**RE: Addendum to Interim Remedial Action at 19984 Meekland Ave., Hayward, Ca.**

Herbert Transportation  
19984 Meekland Avenue  
Hayward, California

- 1) Large Diameter Auger Footprint and Source Removal Map
- 2) Cost Breakdown (Laurie Berger and State UST Fund only)

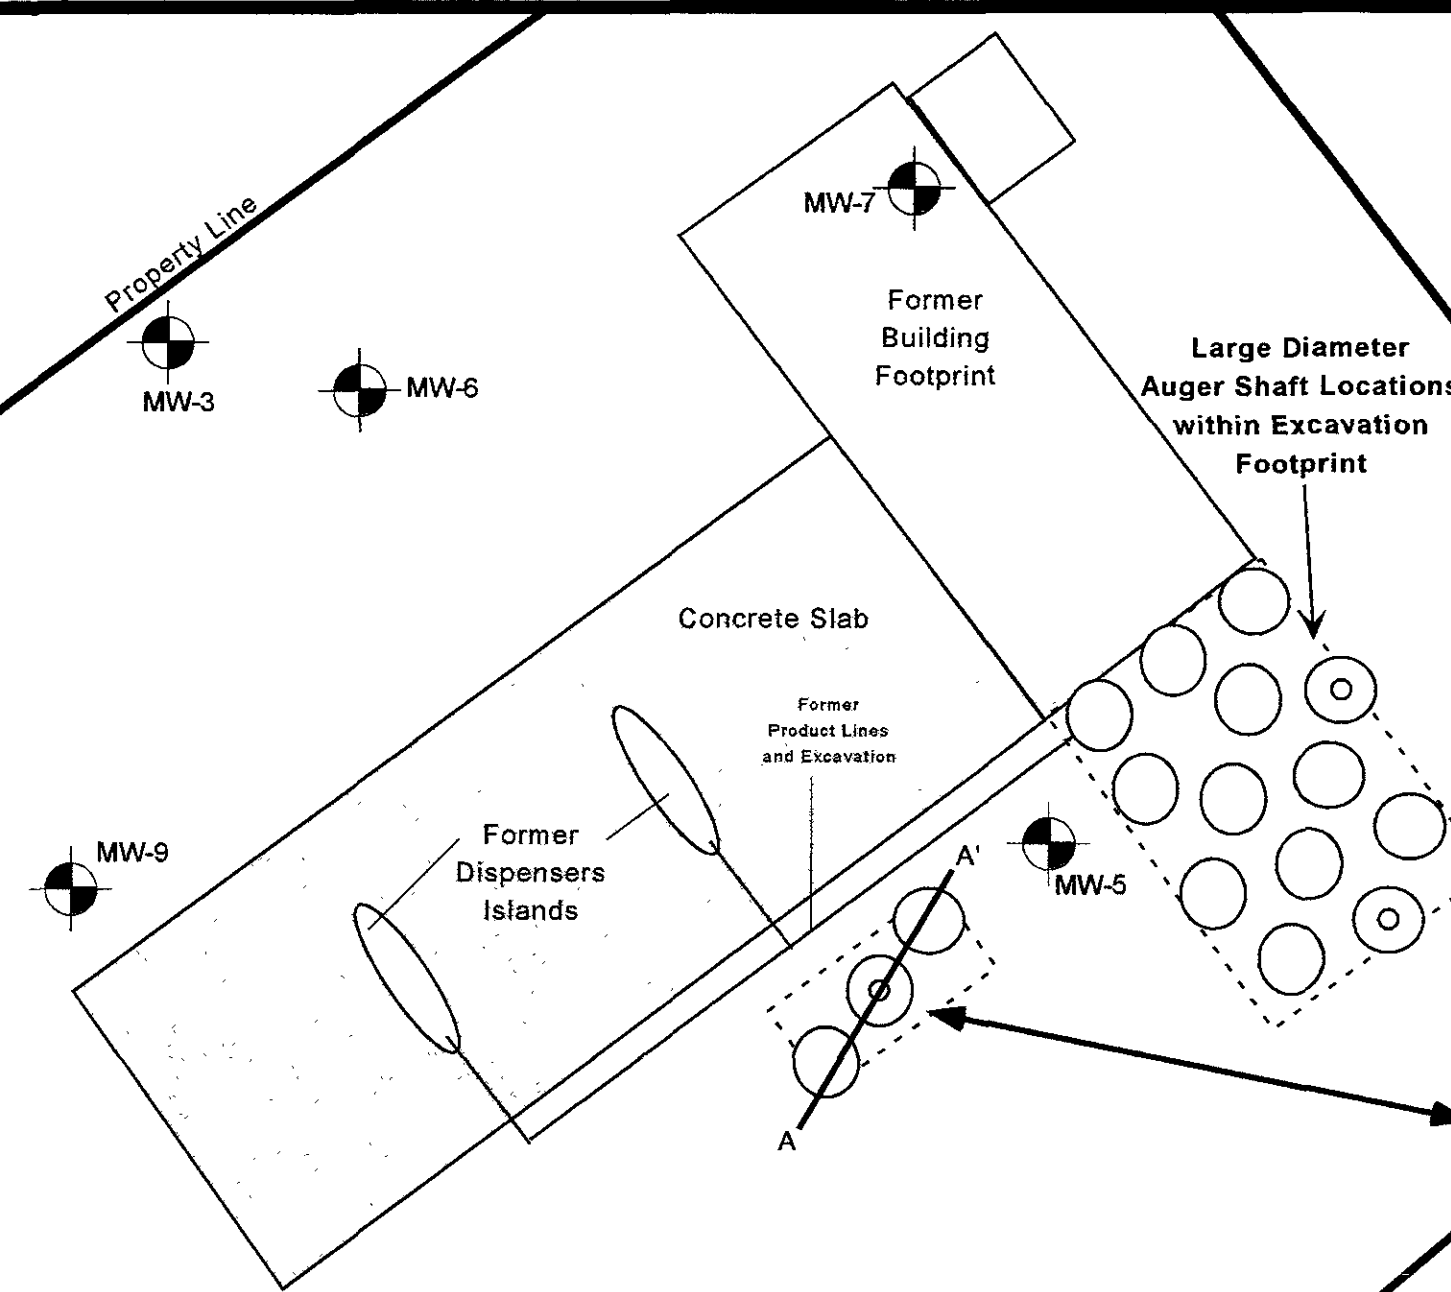
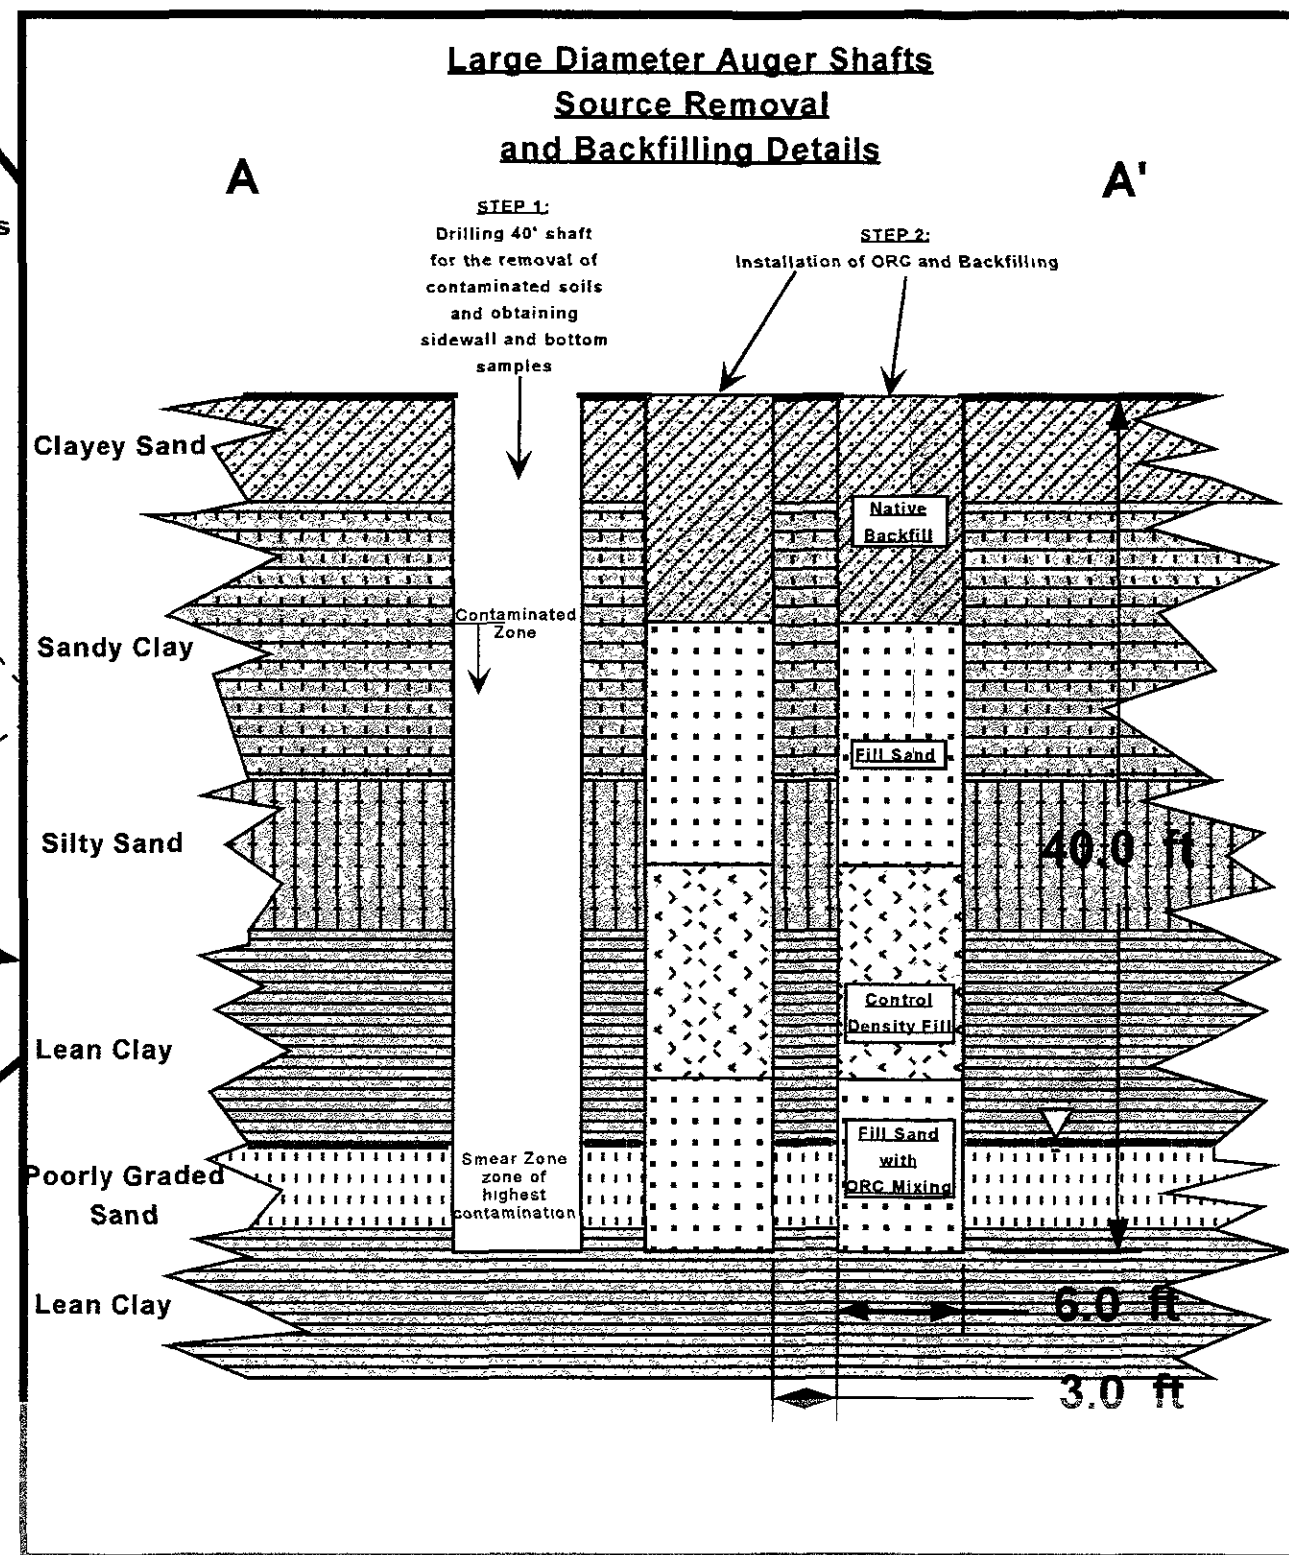
*The initial workplan states excavation operations should go to 25 feet bgs. However upon drilling the landfill acceptance borings and reviewing the delineation investigation borings, it appears that a significant pod of contamination exist in a sand unit at a depth of 34 to 39 feet bgs. Upon drilling the landfill acceptance borings in October, it was discovered that this was the zone that was transporting and smearing the contamination and creating the large groundwater plume that the site is experiencing. WHA proposes to remove the pod of contamination which was not originally identified especially since this deeper sand zone appears to be the remaining source of contamination.*

*WHA proposes to remove source materials by excavating to 40 feet with large diameter augers (6-foot diameter, Case Pacific Drillers) instead of using a excavator. Backhoe-style excavation operations would have been adequate if the excavation was shallow, however due to the depth of contamination encountered (40 feet) excavation operations would require substantial benching, and shoring. Benching and shoring would be difficult, expensive, and generate additional days required to perform the work.*

Because large diameter augers holes must have a few feet of spacing between them to prevent collapse, some soil will not be excavated. This will result in leaving some contaminated soil in place, in the gaps between vertical auger holes (see attached diagram). However, the installation of ORC into the subsurface will help degrade any remaining hydrocarbon contamination. Proposed auger spacing and a cross-section showing depth of auger shafts are presented on the attached Figure - Large Diameter Auger Source Removal Footprint Map.
